City of Stockton – Public Works Department Questions & Answers

Project: New City Hall Renovations and Relocation

Questions & Answers No. 6 – February 28, 2022

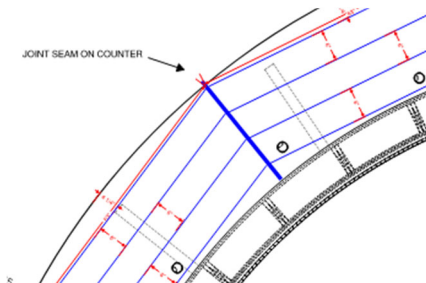
Q3: A5/A-561 –Please clarify material on Dais countertops. You can't possibly want solid wood T&G for countertop? Please clarify?

A3: We do want solid wood with T&G joints. Bid per plans and details. Joint layout will be required in submittal, similar to clip below.
